DEVIATION REQUEST AND DECISION FORM

Project Name : Estates at Cathedral Pines
Schedule No.(s) : 6200000411
Legal Description : TR IN SE4 SEC 2-12-66 DES AS FOLS: BEG AT SW COR OF SE4 SEC 2, TH N 00<49'17" W 1583.77 FT, N 89<17'56" E 965.20 FT, S 00<49'17" E 1583.77 FT TO A PT ON S LN OF SD SE4, TH S 89<17'56" W 965.20 FT TO POB, TOG WITH INGRESS-EGRESS EASEMENT DES BY REC #200027778

DEVIATION REQUEST (Attach diagrams, figures, and other documentation to clarify request) (Date: **Minor Rev. 5/15/2024 to 3/29/24 version**) This deviation request is for intersection spacing and a few other geometric/roadway design elements on **Hamptonshire Point**. As such, this deviation includes several itemized parts/elements. Please refer to deviation exhibits 1 – 6b. Deviation Exhibit 1 shows the location of this street on the site plan map.

Deviation Exhibit 1
Deviation and Waiver Vicinity Map
Estates at Cathedral Pines (LSC# S224150)

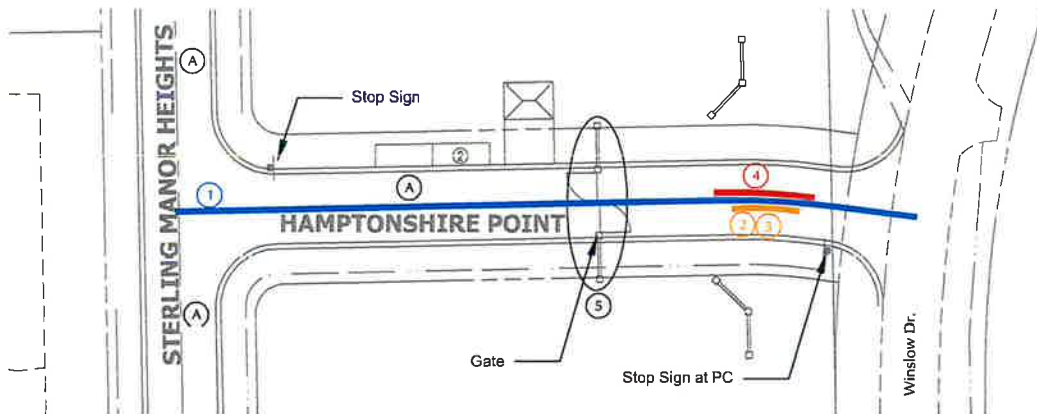
Note: for reference, Deviation Exhibit No. 1 also shows the location of the **Land Development Code Waiver** for private roads (please refer to the separate waiver request document). Deviation Exhibit No. 2 shows the detailed locations of the parts/elements of this deviation.

ACCESS CL PROFILE STA 1+00.00 TO 3+99.27

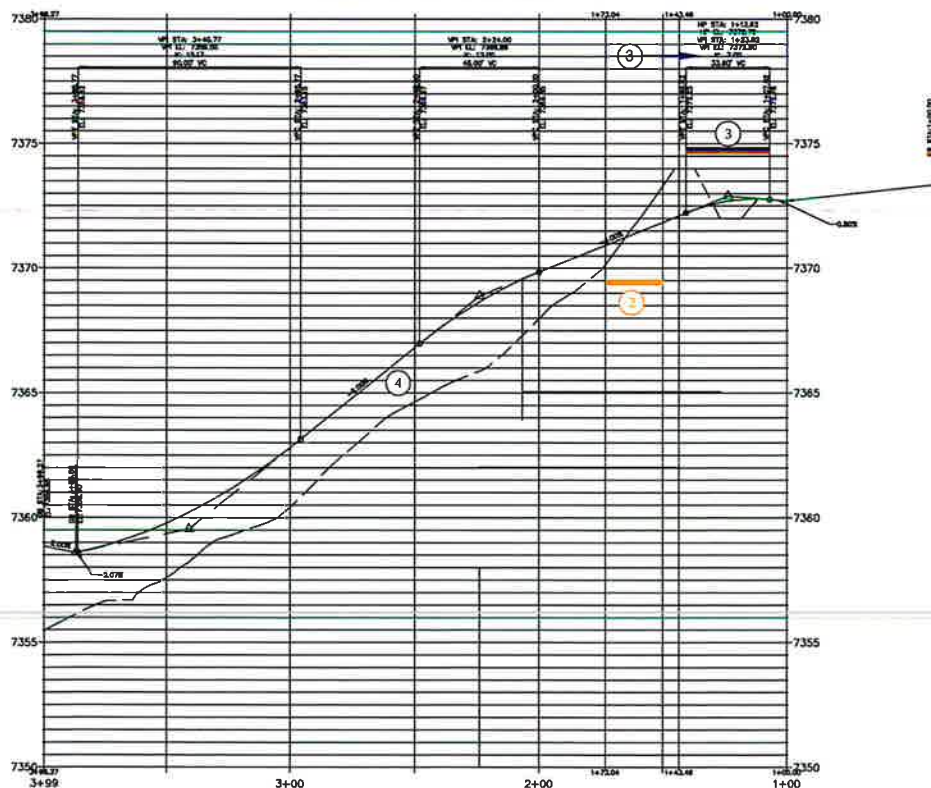
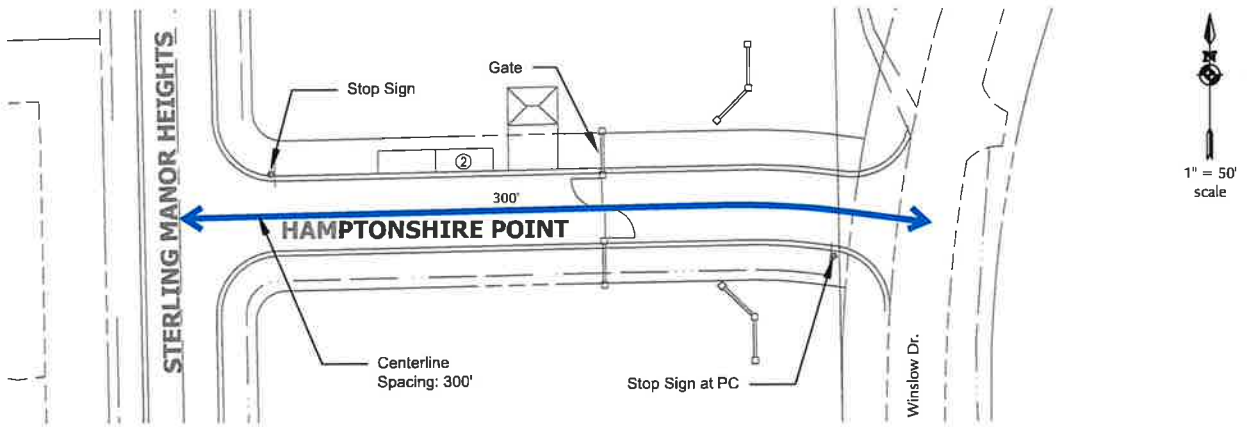
- ① ECM Table 2-5 -- Intersection spacing along a Rural Local Road
 Segment of Hamptonshire Point for which deviation is requested
 330' = ECM requirement
 300' = proposed conditions

- ② ECM Table 2-5 -- Minimum centerline curve radius for a Rural Local Road
 Location of centerline curve radius on Hamptonshire Pt. for which deviation is requested

- ③ Table 2-12 -- K value less than ECM minimum of 19 for a design speed (by road classification) of 30 mph
 Location of vertical curve radius on Hamptonshire Pt. for which deviation is requested

- ④ Table 2-5 -- Eastbound Intersection grade of > 4% (exceeding the ECM minimum intersection approach grade)- Potential/possible "stop condition" for exiting traffic with the proposed gate (similar to an intersection) on a grade > 4%. However, the gate system selected for use may be capable of opening so exiting vehicles do not need to stop on the eastbound approach to the gate.

Site-Specific Situation

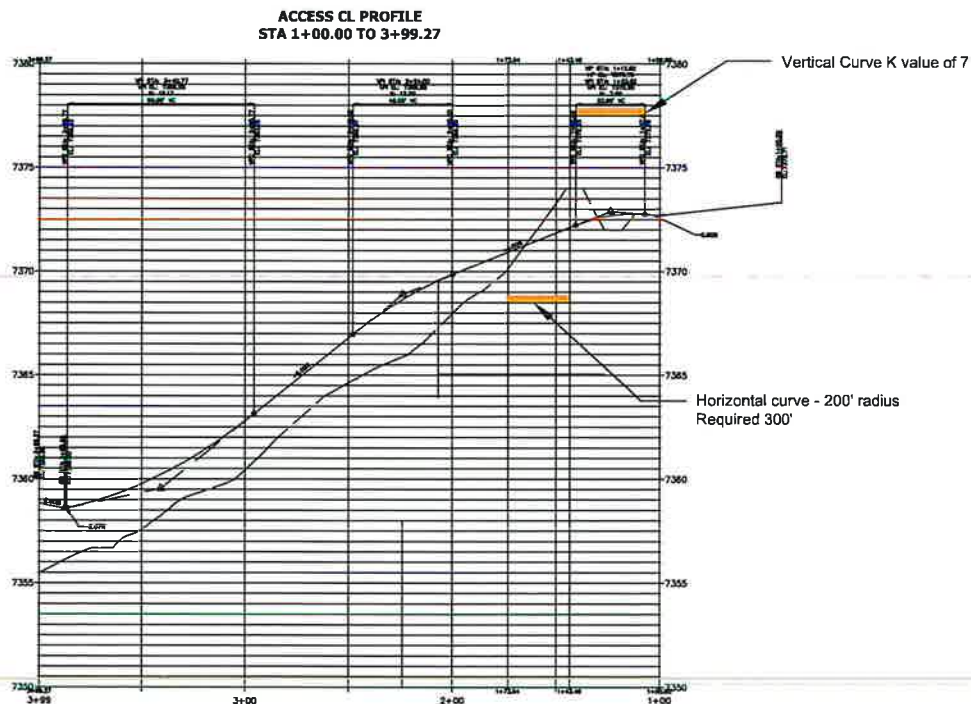
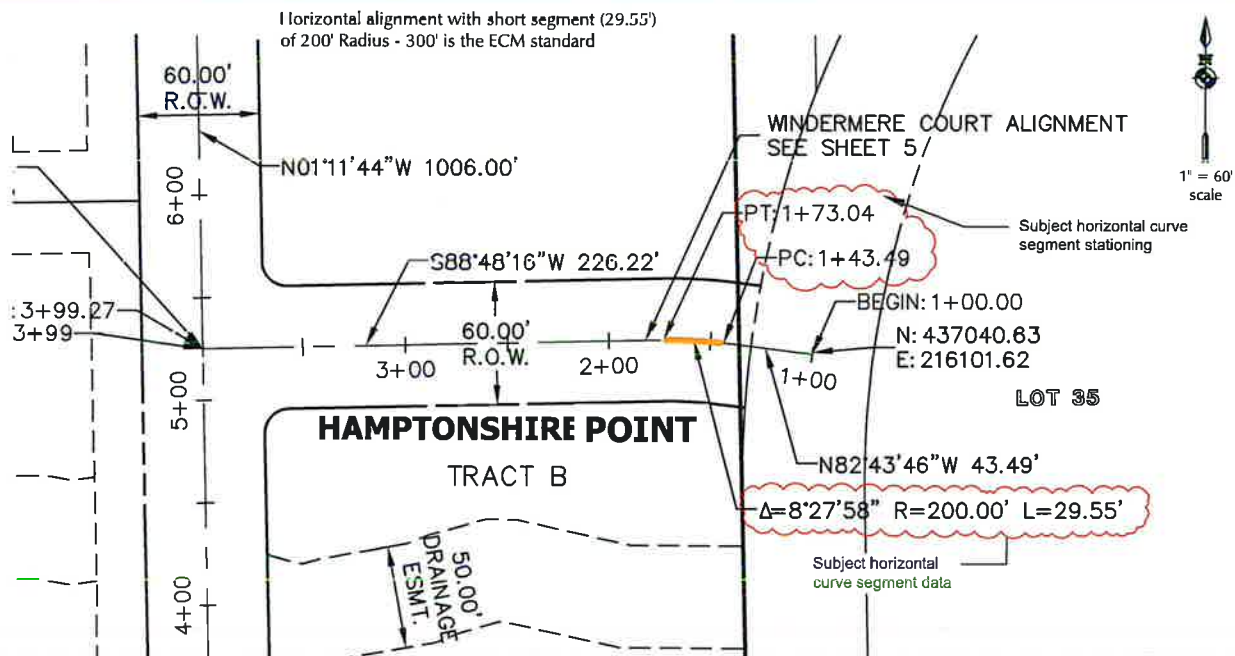
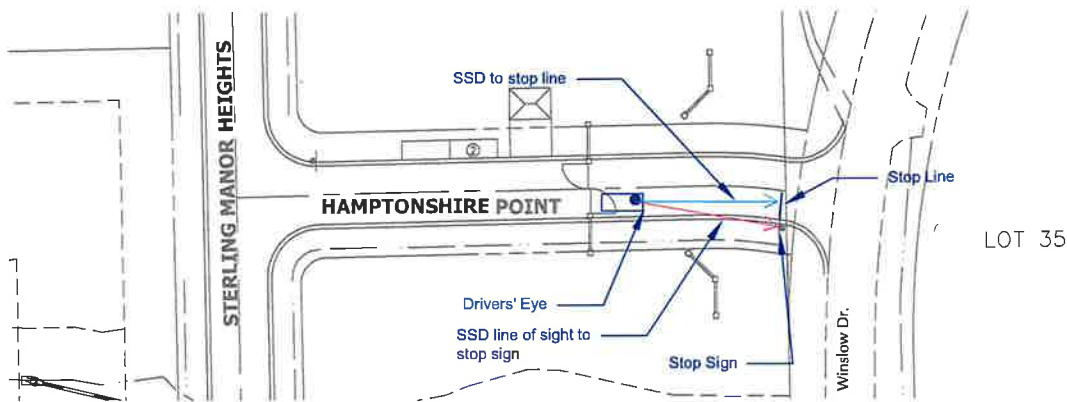
Local roadway intersection spacing shall be 330 feet (centerline spacing). Please refer to Deviation Exhibit No. 3.

ECM's standard requires intersection spacing of 330 feet (centerline-to-centerline) on Rural Local roads. The centerline spacing along Hamptonshire Point between the Sterling Manor Heights/Hamptonshire Point intersection and the Winslow Drive/Hamptonshire Point intersection would be 300 feet.

The proposed spacing is only 50 feet short of the ECM standard, there would be no east leg of the intersection of Winslow Drive/Hamptonshire Point and no west leg of the Hamptonshire Point/Sterling Manor Heights. This site-specific road configuration is significantly different from the more generic configuration which the ECM standard is intended to cover. As shown in Deviation Exhibit 3, the ECM standard covers the generic/hypothetical local street spacing scenario with series of local cross streets, with through traffic at the design speed through a series of local street intersections. The spacing criteria of 330' was established largely due to stopping sight distance for the design speed along the through roadway. Vehicle speeds along this street will be limited and the 330' for stopping sight distance for eastbound/westbound motorists would not be necessary. This will be a small subdivision with low traffic volumes.

The requested spacing of 300 feet vs. 330 feet is reasonable given the site-specific road configuration with stop signs on each end, as described above. Vehicle speeds along this street will be limited and the 330' for stopping sight distance for eastbound/westbound motorists would not be necessary.

ECM standard covers this hypothetical local street spacing scenario with series of local cross streets, with through traffic at the design speed through a series of local street intersections. The spacing criteria of 330' was established largely due to stopping sight distance for the design speed along the through roadway.

In this situation, the 300' Hamptonshire Pt. segment, there is no "through" traffic at the intersection with Sterling Manor Hts. and Winslow Dr., and likely with stop signs for east and westbound traffic on each end, at these T intersections.

Deviation Exhibit 5 Stopping Sight Distance (SSD) - Exiting Vehicle*

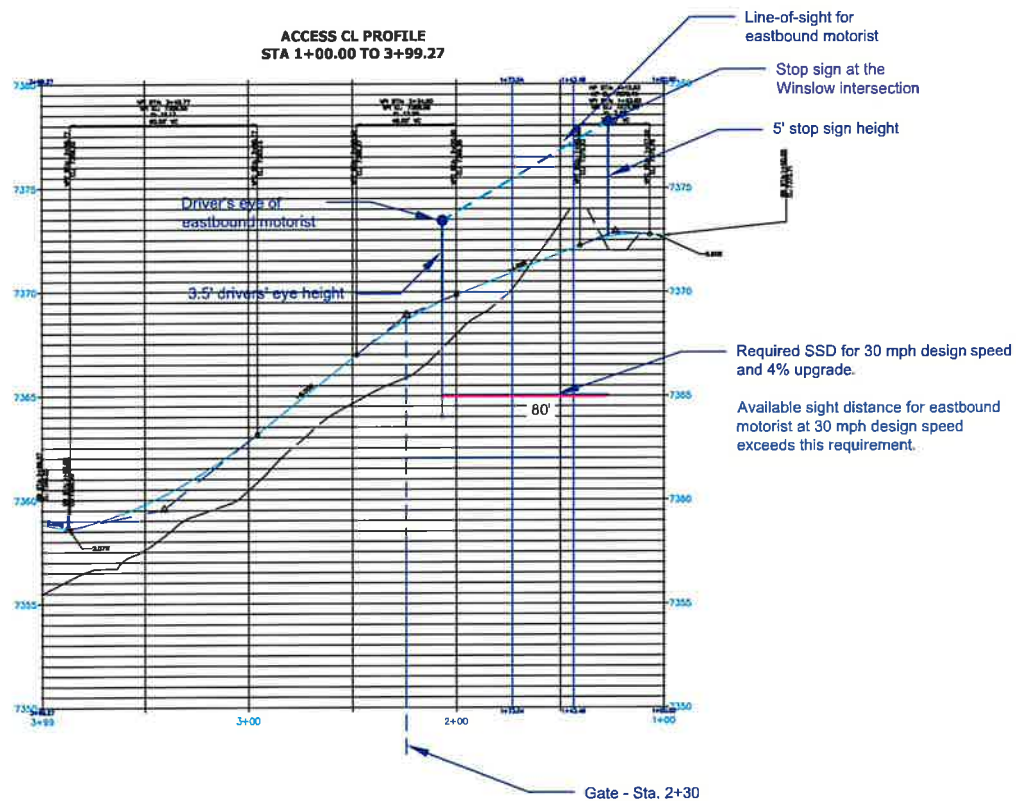
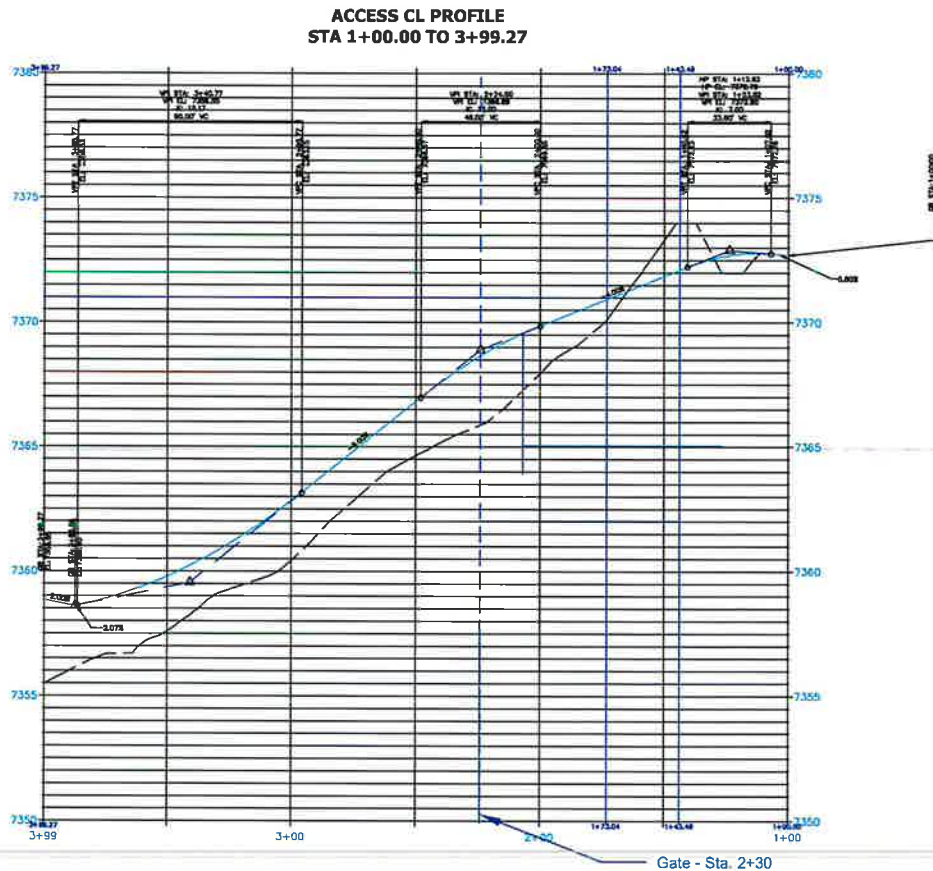
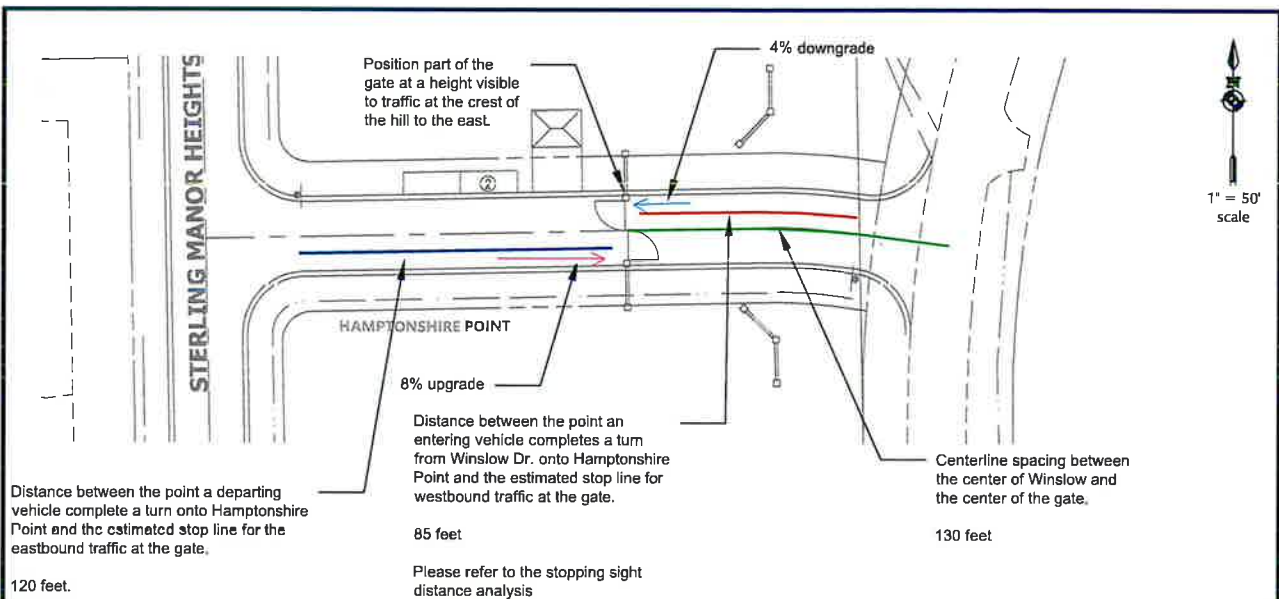
K-values less than 19 shall not be permitted on a roadway with a design speed of 30 mph. Please refer to Deviation Exhibit No. 5.

The proposed K-value on Hamptonshire Point is 7, while the ECM requires that roadways with a design speed of 30 mph use a K-value of 19 when designing for the rate of vertical curvature.

Deviation Exhibit 5 presents the sight-distance analysis across the vertical curve on Hamptonshire. Per Table 3-2 of AASHTO's *A Policy on Geometric Design of Highways and Streets*, the required stopping sight distance on a roadway with a 6-9 percent downgrade is 85 feet, while the required stopping sight distance for a roadway with 6-9 percent upgrades is 73 feet. As indicated in Deviation Exhibit 5, both of these stopping sight distance requirements would be met.

*Analysis of stopping sight distance in the eastbound direction for a motorist exiting the subdivision at the vertical curve on Hamptonshire

Deviation Exhibit 6b
Estates at Cathedral Pines (LSC# S224150)

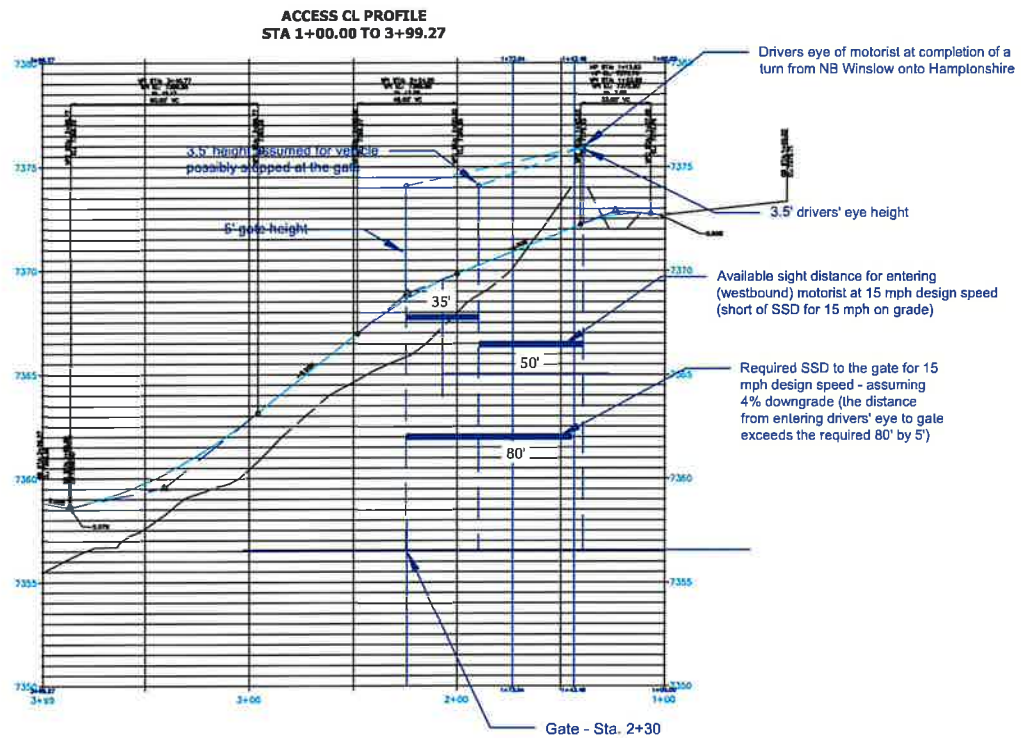
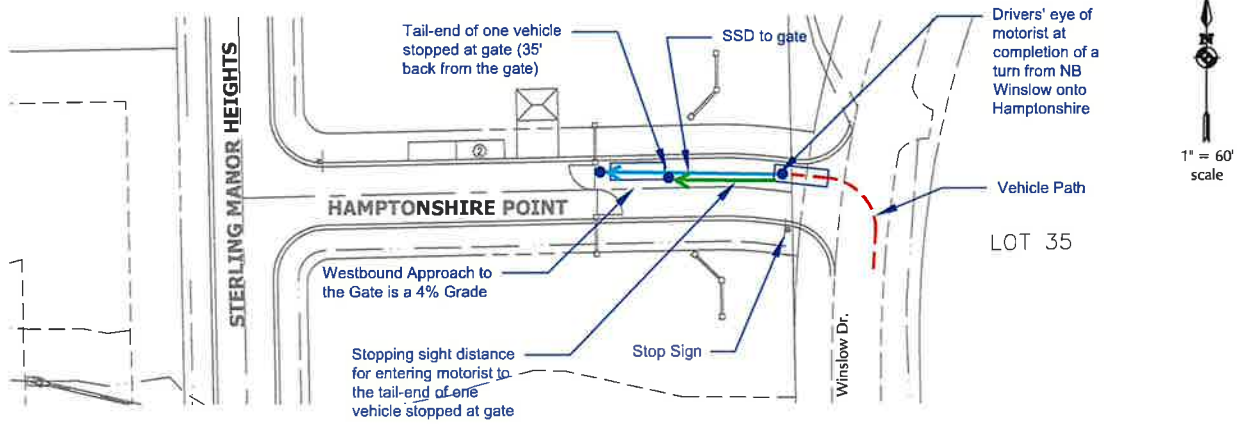
ECM Section 2.3.6.D, Table 2-17: Stopping Sight Distances at Grade. The stopping sight distance for 30-mph design speed (speed-by-classification) on a Rural Local roadway per ECM Table Section 2.3.2, Table 2-5, and stopping sight distance on a grade, as per ECM Section 2.3.6.D, Table 2-18. Please refer to Deviation Exhibit No. 6b.

ECM Section 2.3.6.D, Table 2-17: Stopping Sight Distances at Grade. The stopping sight distance for 30-mph design speed (speed-by-classification) on a Rural Local roadway per ECM Table Section 2.3.2, Table 2-5, is 227 feet on a grade of up to 9 percent (per ECM Section 2.3.6.D, Table 2-18). The available stopping sight distance is 85 feet to the proposed gate and 50 feet to the estimated tail-end of one passenger vehicle queued at the gate.

*Analysis of stopping sight distance for a motorist entering the subdivision in the westbound direction on Hamptonshire following a turn from northbound or southbound Winslow.

Stopping Sight Distance - Entering Vehicle*
